**DECISION DOCUMENT**

**TWENTY-SIX NO FURTHER ACTION SITES**

SEPTEMBER 2001

Parsons Engineering Science, Inc  
30 Dan Road  
Canton, Massachusetts 02021

SENECA ARMY DEPOT ACTIVITY

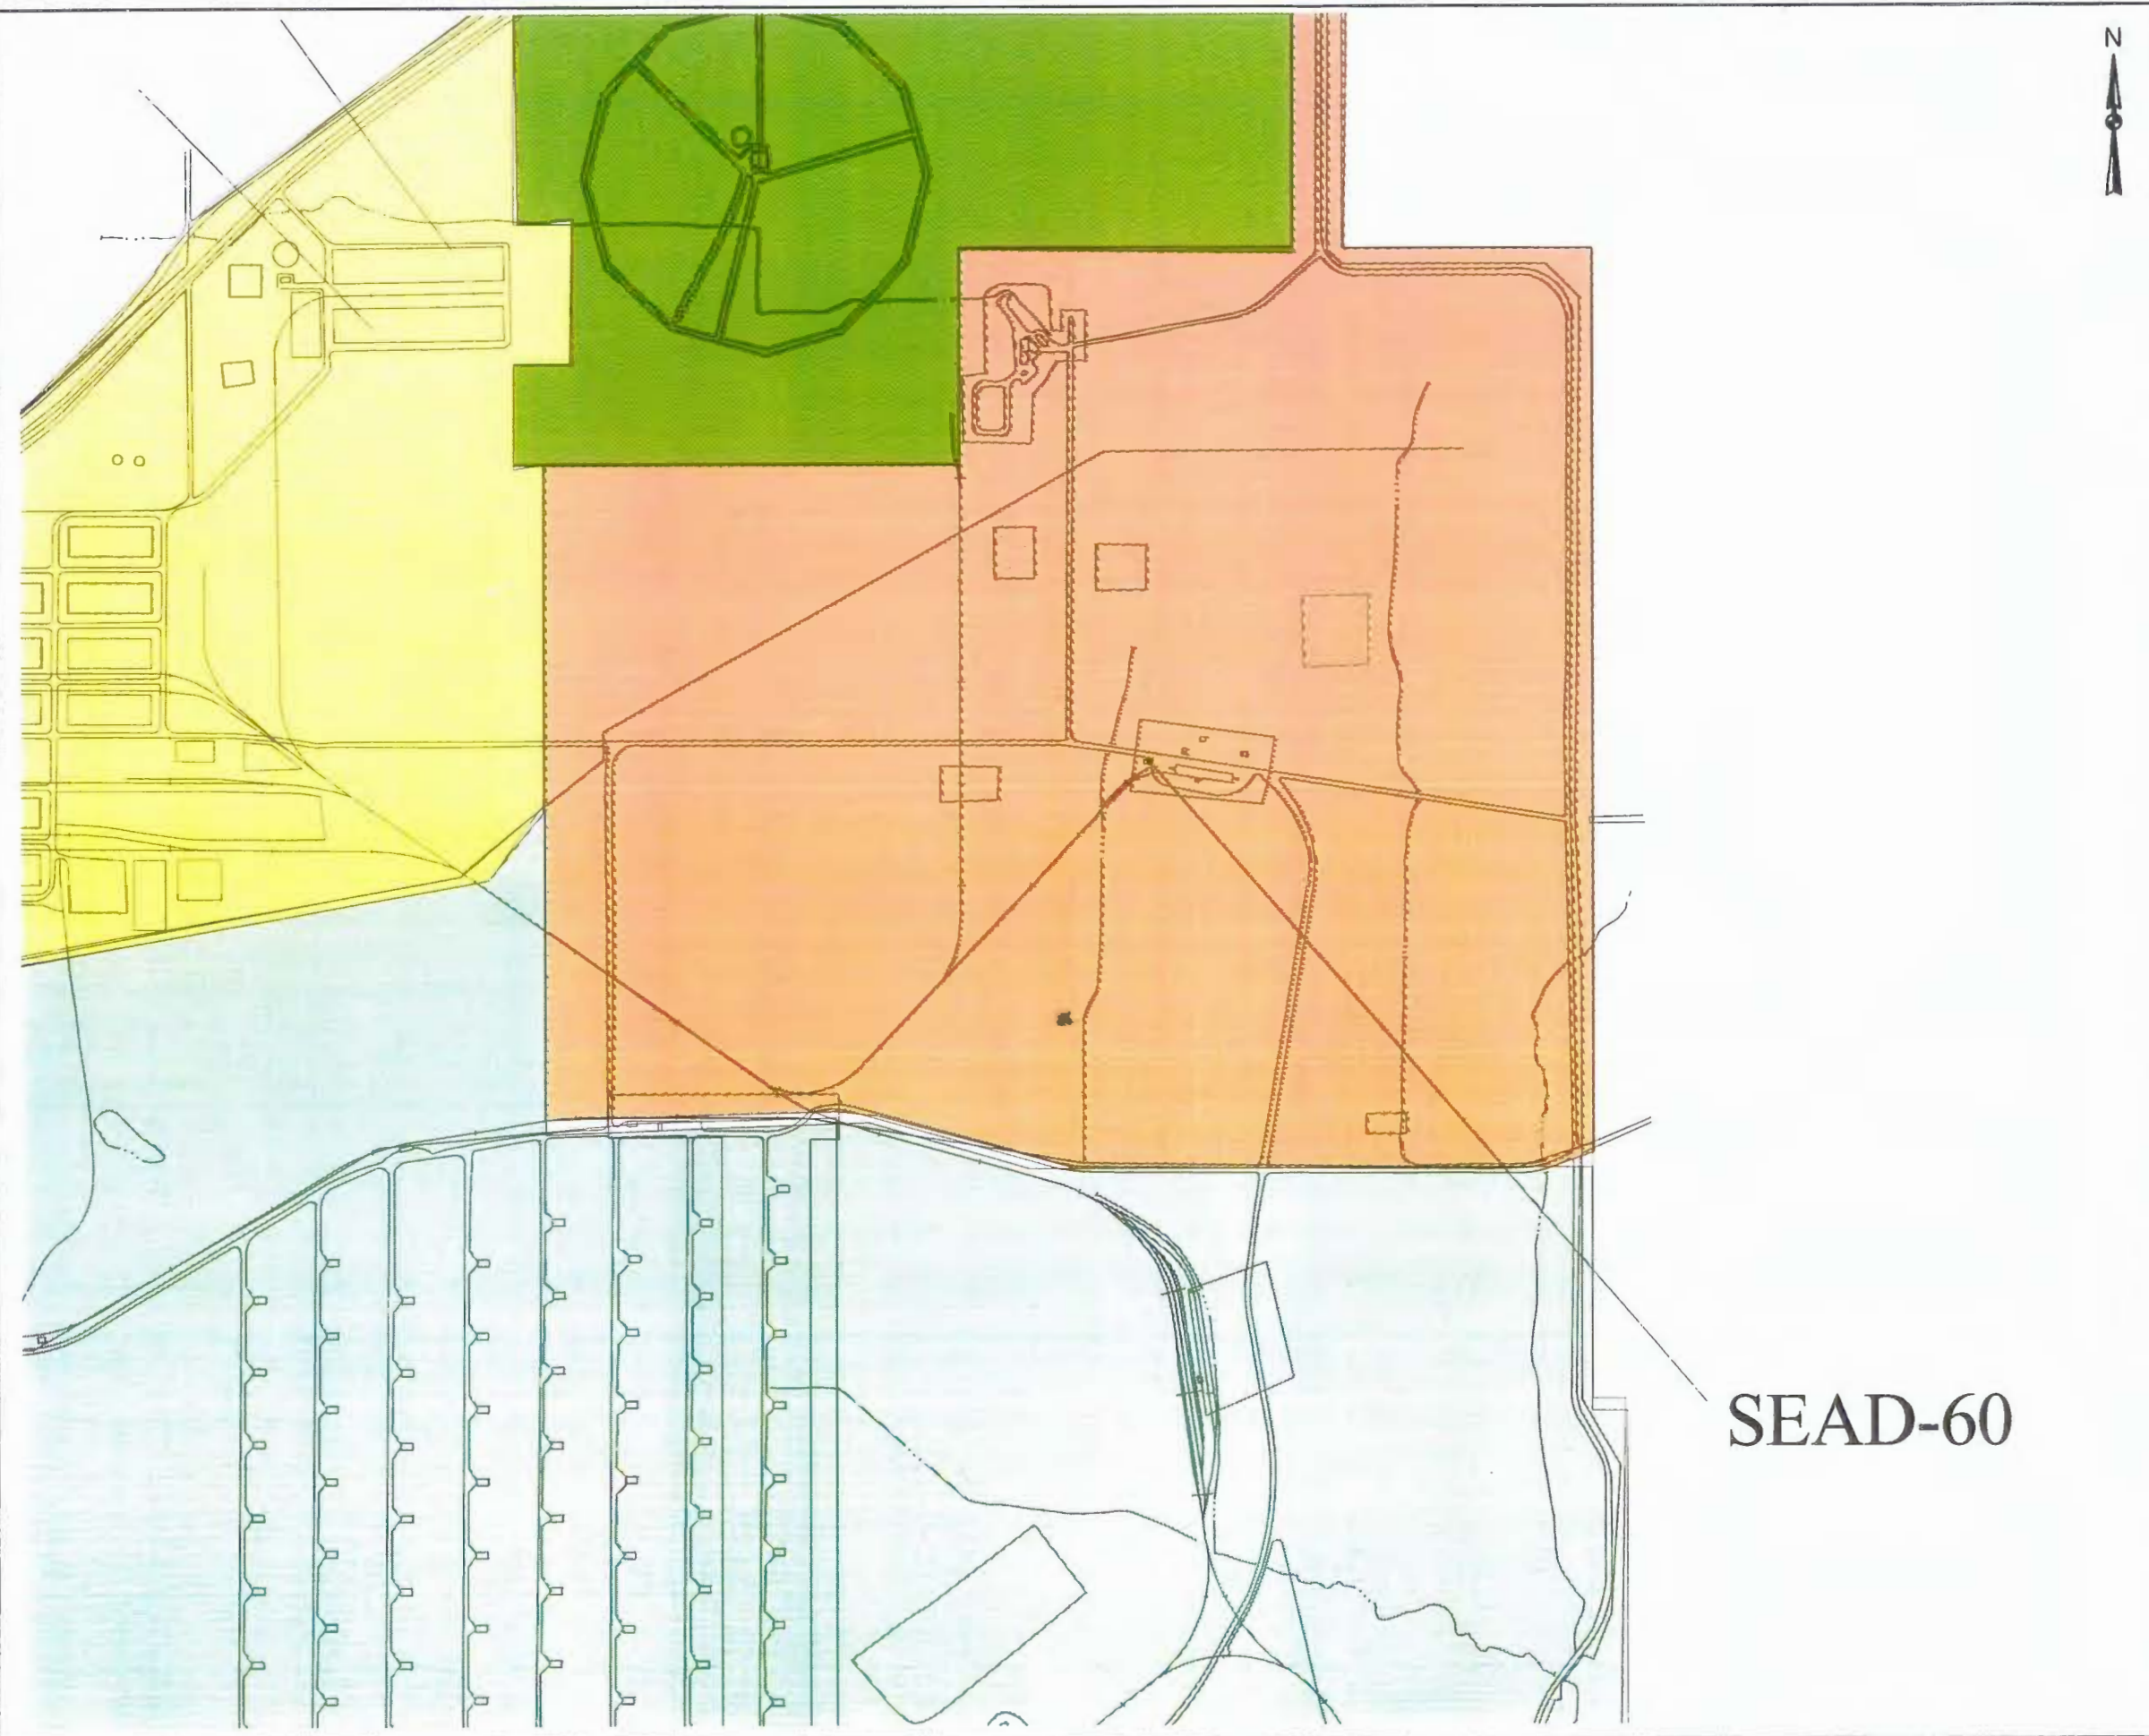
1. There seems to be a typographical error on the number for the first figure of Chapter 2. Referenced Figure 2-1 cannot be found in the document. Please include more specific maps for the different areas (i.e.. North End, PID, Warehouse, Q, etc.).
